MARICOPA COUNTY
Department of Transportation

MEMORANDUM

Subject: Revision to Section 405 MONUMENTS and Detail 120

Case 14-02

SURVEY MARKER

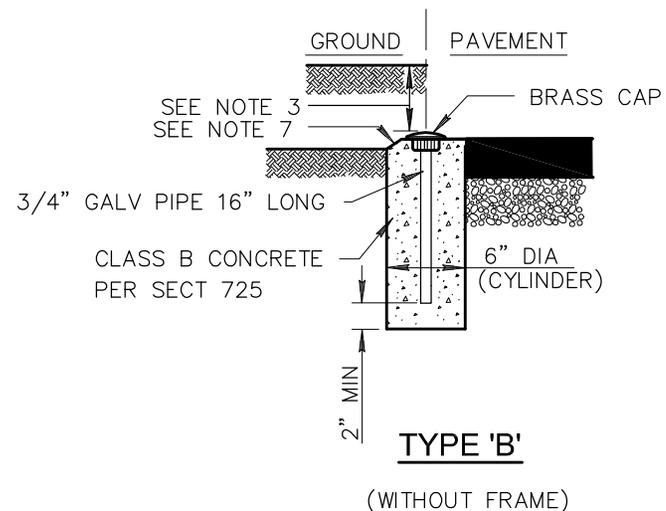
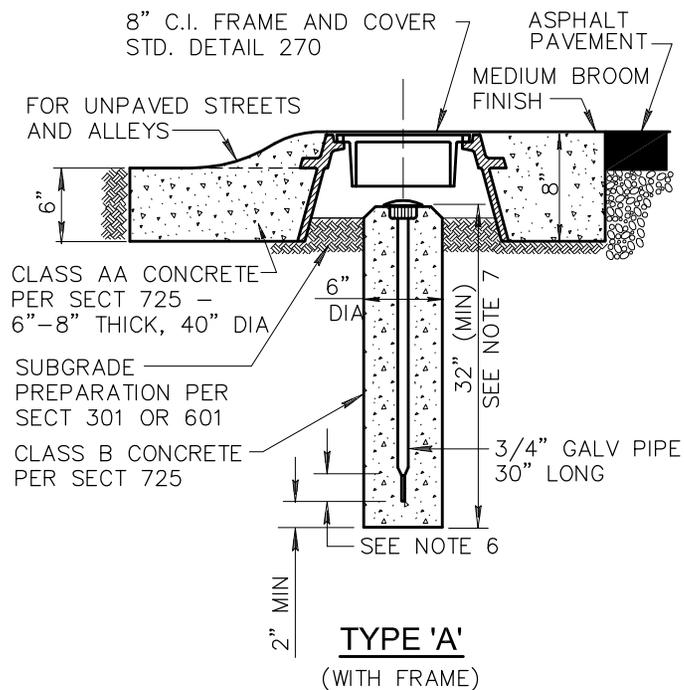
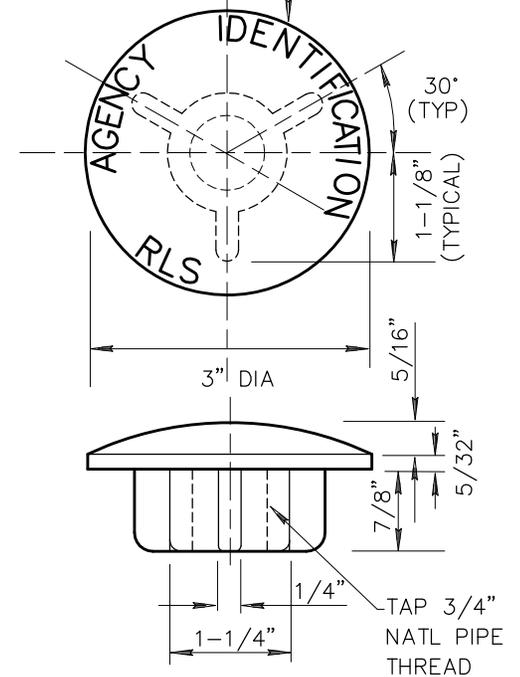
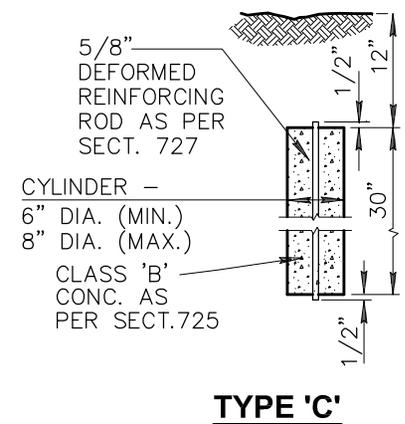
PURPOSE: Updated specification to match current details and requirements.
Deleted the usage note for Type C Monument (prior note #3).
Modified Type B Monument to have the depth recessed six inches below finished grade when located in an unpaved roadway or alley.

3. FOR UNPAVED STREETS AND ALLEYS SET TOP OF MARKER SIX INCHES BELOW FINISHED GRADE.
4. CAP TO BE CONSTRUCTED OF RED BRASS OR BRONZE.
5. LETTERS TO BE APPROX. 1/32" WIDE & 1/32" DEEP.
